STAFF REPORT
WEST ALLIS PLAN COMMISSION
Wednesday, March 28, 2018
6:00 PM
ROOM 128 – CITY HALL – 7525 W. GREENFIELD AVE.

- 4A. Special Use Permit for Pho Saigon, a proposed restaurant, to be located at 10534 W. Greenfield Ave.**
- 4B. Site, Landscaping and Architectural Plans for Pho Saigon, a proposed restaurant, to be located at 10534 W. Greenfield Ave., submitted by Barry Yang, AIA, d/b/a Barry C. Yang Architect. (Tax Key No. 444-0511-001 and 444-0513-000)**

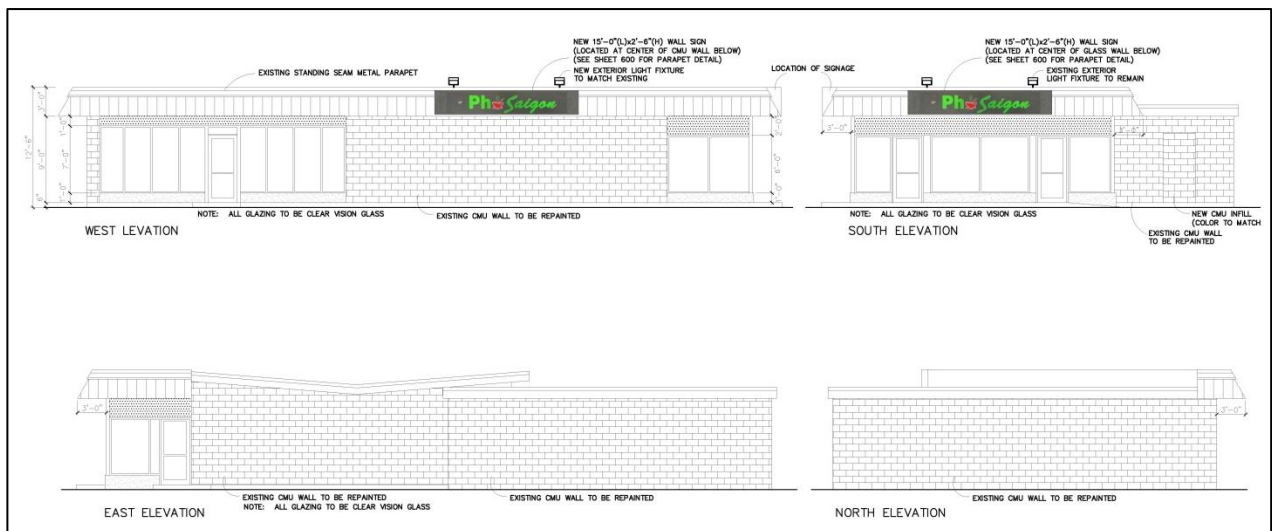
Minor changes to the parking configuration are also proposed, though the layout will remain very similar to what currently exists. A loading zone shown to the north of the building would adjoin space currently used as a refuse area. The refuse area is currently screened by a six foot wood fence. There are currently no proposed improvements to the fence, though staff recommends a new fence for this area as the current one is damaged in several areas.

There are a few additional details that staff would like to see on the landscape plan. Some of the curbing, specifically the southwestern corner of the site, is broken up. Fixing areas with broken curbing is not currently shown on the site, and staff would recommend adding a condition of approval to address the curbing. In addition, the current patio area features wood planks that are dilapidated. The current plans show that the patio area will be extended, although no improvement to the current patio area is proposed. Staff recommends removing all of the wood planks and infilling with a durable material such as concrete.

Currently, the two parking areas are in different states of repair. The asphalt of parking area to the east of the building is in good condition. However, the area west of the building has several uneven areas and cracked asphalt. There are no proposed improvements to the parking area at this time, but staff recommends that this area be repaired.

The curb cut along S. 106 St. was previously narrowed. However the geometry shown on plan should be corrected to reflect the actual as-built situation on site.

1. Revised Site, Landscaping and Architectural Plans being submitted to the Department of Development to show the following: (a) plans to note curbing repair along the southwestern corner of the site; (b) pavement repair being noted within the west parking area; (c) exterior color, door and window details; (d) new wood refuse enclosure being indicated on plan (provide detail); (e) removal of the damaged checkered accent panel and LED lighting along the roofline; (f) Exterior lighting details being provided. Existing soffit lighting being repaired, and a decorative style of exterior signage lighting is recommended; (g) removal of the existing patio wood plank surface within the existing patio area for a more durable paved surface; (h) replace the east and west side exterior doors. Details being provided; (i) curb cut geometry along S. 106 St. being corrected on plan to fit as built situation; (j) removal of the existing wood header board on the east side of the building (previously supported a pergola feature which no longer exists); (k) bike rack/parking being noted on site and details of an inverted-u rack being noted. Contact Steve Schaer, Planning Manager at (414) 302-8466 with any questions.
